COMMUNICATIONS - AIRCELL ATG ANTENNA ELECTRICAL BONDING IMPROVEMENT

MODEL	SERIAL NUMBERS
750 (Citation X)	-0170, -0307 thru -0500

SB750-23-21  
Page 1 of 6

Figure 1. Aircell ATG Broadband Antenna Electrical Bonding Improvement (Sheet 1)

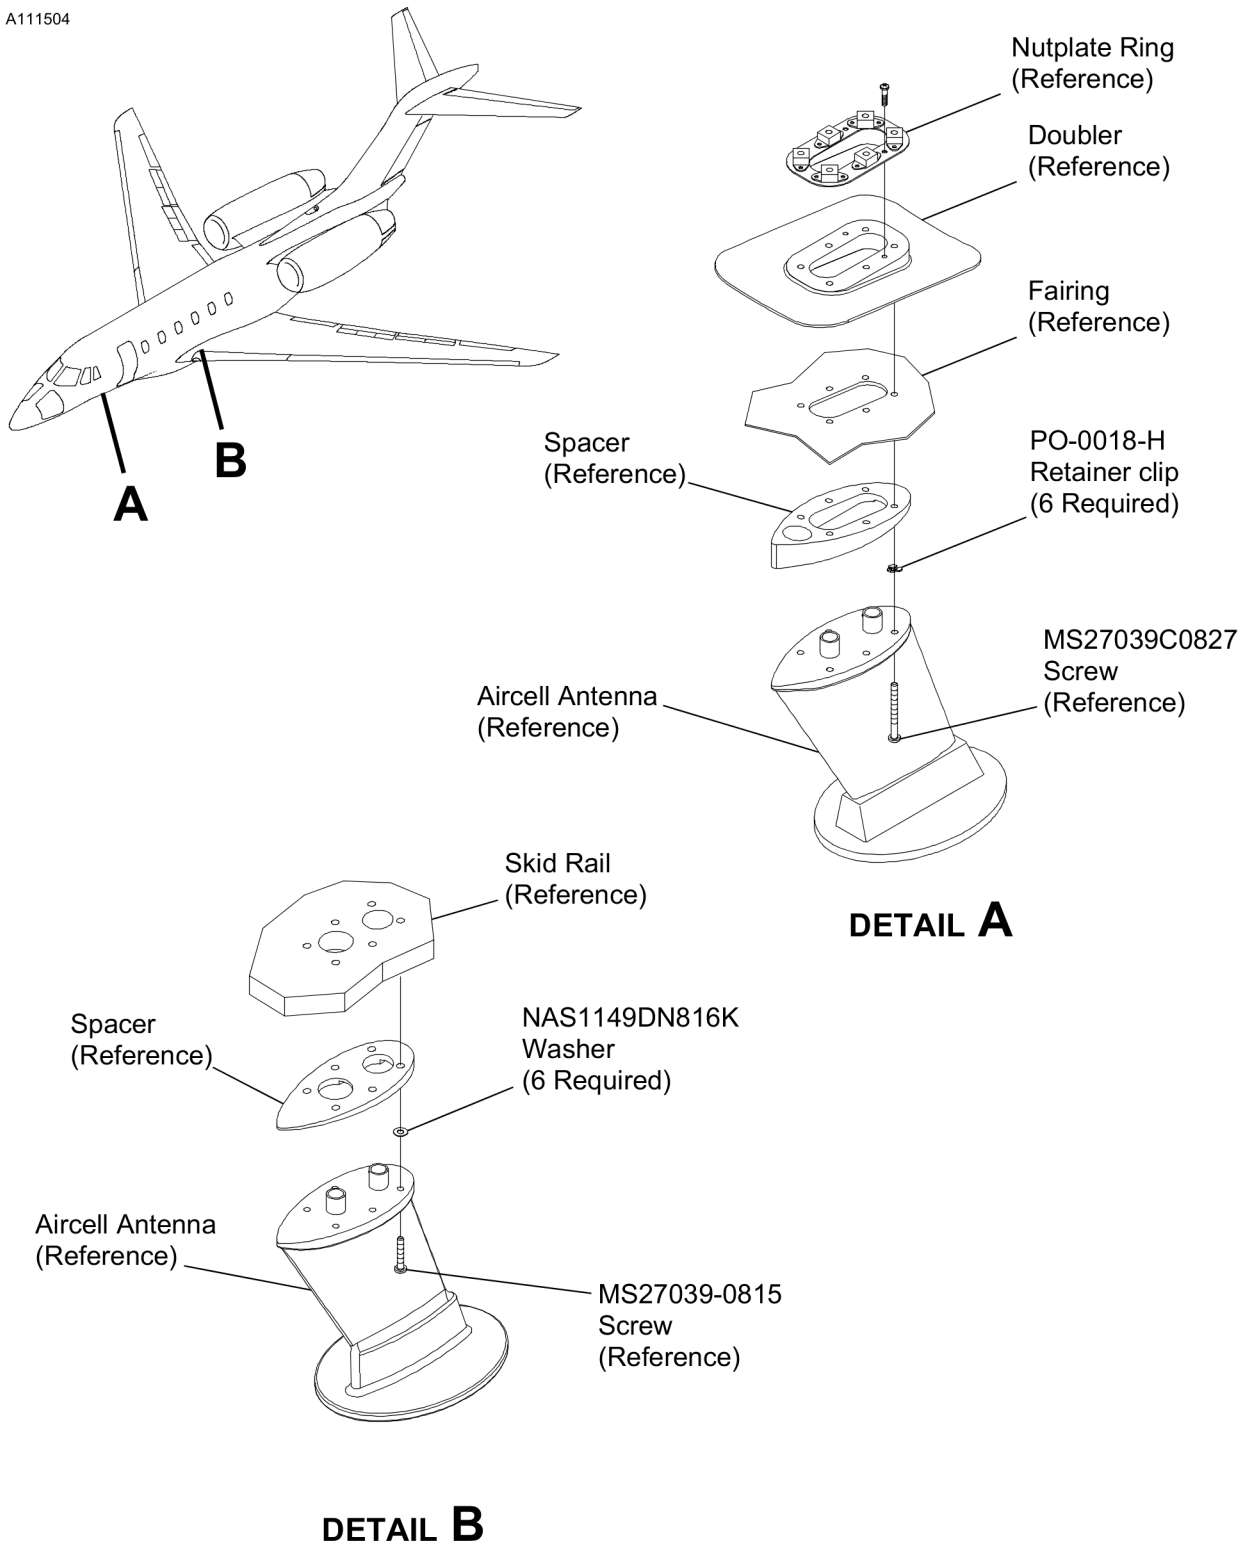
The electrical bonding of the Aircell ATG Broadband Antennas can fluctuate which may cause connectivity issues.

This service bulletin contains parts and instructions to add bonding clips and washers to the Aircell ATG Broadband Antenna installations.

5. (Refer to Figure 1, Detail A.) Install the forward Aircell ATG Broadband Antenna as follows:
  - A. Prepare the 154AB access panel for electrical bonding as follows:

- (8) Install six MS27039C0827 Screws in the antenna.
  - (9) (Refer to Figure 1, Detail A.) Install one PO-0018-H Retainer Clip on each screw.
  - (10) Apply a fay seal to the upper and lower surfaces of the spacer using U470638 Sealant. (Refer to the Citation Standard Practices Manual, Chapter 20, Fuel, Weather, Pressure, and High-Temperature Sealing - Maintenance Practices.)

**NOTE:** Make sure the fay seal is thick enough to fully cover the PO-0018-H Retainer Clips without any voids in the sealant.
  - (11) Install the spacer on the Aircell ATG Broadband antenna.

- (13) Torque the MS27039C0827 Screws. (Refer to the Citation Standard Practices Manual, Chapter 20, Torque Data - Maintenance Practices.)
  - (14) Make sure there is a Type I electrical bond between the spacer and the MS27039C0827 Screws. (Refer to the Citation Standard Practices Manual, Chapter 20, Electrical Bonding - Maintenance Practices.)

- (15) Make sure that there is a Type I electrical bond between the antenna doubler and the nutplate ring. (Refer to the Citation Standard Practices Manual, Chapter 20, Electrical Bonding - Maintenance Practices.)

- (16) Make sure that there is a Type V electrical bond between the antenna base and the screw countersinks in the 154AB access panel. (Refer to the Citation Standard Practices Manual, Chapter 20, Electrical Bonding - Maintenance Practices.)

- (20) Apply a fillet seal around the base of the Aircell Antenna and spacer using U470545 Sealant.
6. (Refer to Figure 1, Detail B.) Install the aft Aircell ATG Broadband Antenna as follows:

- (2) Using a 0.50 inch (12.7 mm) bonding brush, remove the exterior finish from mating surface of each spacer mounting holes.

- (4) Install six MS27039-0815 Screws in the antenna.
- (5) (Refer to Figure 1, Detail B.) Install one NAS1149DN816K Washer on each screw.
- (6) Apply a fay seal to the mating surface of the spacer using U470638 Sealant. Except for around the 0.50 inch (12.7 mm) diameter electrical bond of each mounting hole. (Refer to the Citation Standard Practices Manual, Chapter 20, Fuel, Weather, Pressure, and High-Temperature Sealing - Maintenance Practices.)

- (9) Torque the MS27039-0815 Screws. (Refer to the Citation Standard Practices Manual, Chapter 20, Torque Data - Maintenance Practices.)
- (10) Make sure that there is a Type I electrical bond between the Aircell Antenna and the antenna mount. (Refer to the Citation Standard Practices Manual, Chapter 20, Electrical Bonding - Maintenance Practices.)
